BCA COMPLIANCE ASSESSMENT REPORT

Building Code of Australia 2022 Amendment 2

PROJECT:	32-34 Kent Street, Belmore
REF. No.:	NEW250718 (Rev 3)
DATE:	22/07/2026
CLIENT:	Multiform D & C
CONTACT:	Mirwan Hanna
EMAIL:	mirwan@multiform.net.au
CONSULTANT:	Mauricio Vera
PHONE No:	0451 078 790
EMAIL	mvera@newcrown.com.au

2. Clause D2D5: Exit travel distances

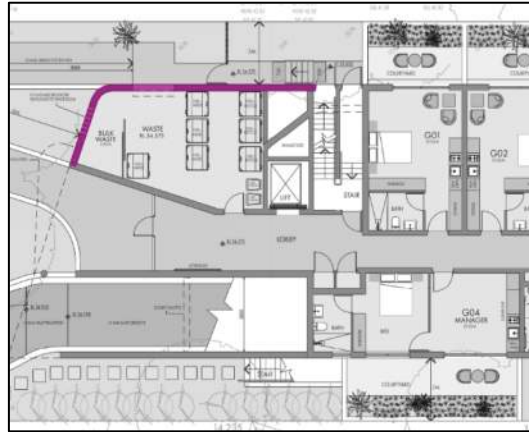
Excessive travel distances to a single exit have been identified as outlined below. Refer to Addendum D at the back of this report for travel distances markup.

- Levels 1-5 (SOU): Up to 18m in lieu of 6m max.
- Ground floor (occupiable outdoor area): Up to 35m in lieu of 20m max

Design rectification is recommended. Alternatively, Fire Engineer to assess if a Performance Solution is feasible.

4. Clause D3D25: Swinging doors

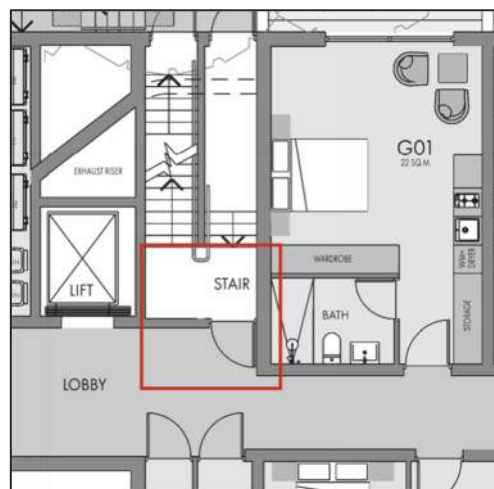
Exit door (lobby) to fire-isolated stair swings against the egress direction, in compliance with this clause. Design rectification is recommended. Alternatively, Fire Engineer to assess if a Performance Solution is feasible.
